SERVICE NEWS

APRIL, 1963

SERVICING CORVAIR ENGINE VALVES AND VALVE GUIDES

Fig. 5—Pinion Shaft Front Bearing Seal

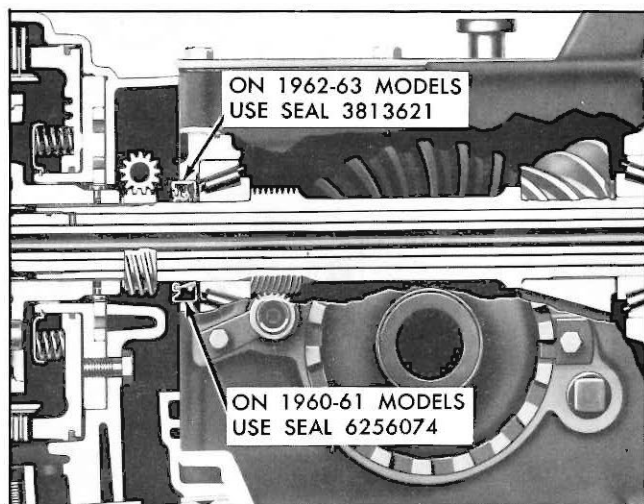
utilize a double lip seal (Part No. 3813621) as the drive pinion shaft front bearing seal (Fig. 5). A single lip seal (Part No. 6256074) was formerly used at this location. The 3813621 double lip seal is now available for service and is recommended for use on 1962-63 models. Replacement usage of the single lip seal, Part No. 6256074, should be restricted to the 1960-61 model vehicles.

To provide improved sealing it is now recommended that pinion front bearing seals, whether of the single or double lip type, be positioned at installation so that the sealing lip having the garter spring will be located adjacent to the bearing. Seal Installer J-8340 will protect the seal from

Fig. 6—Chevy II Strut Rod Attachment

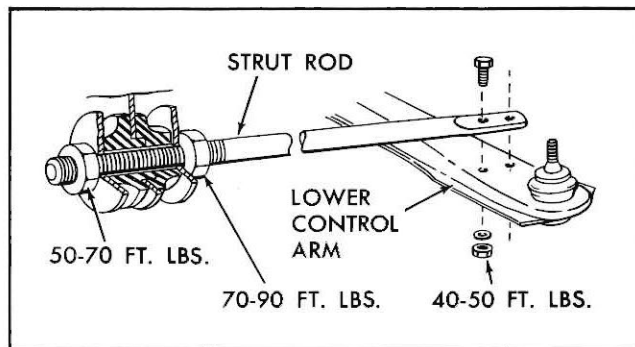
Torque specifications for installation of the lower control arm strut rod attaching parts on 1962-63 Chevy II vehicles are shown in Figure 6.

Strut rod attaching parts installation torques shown on pages 3-16 and 14-1 of the 1962 Chevy II Shop Manual and on page 14-1 of the 1963 Chevy II Shop Manual Supplement should be revised to conform with torques specified in Figure 6 of this issue.
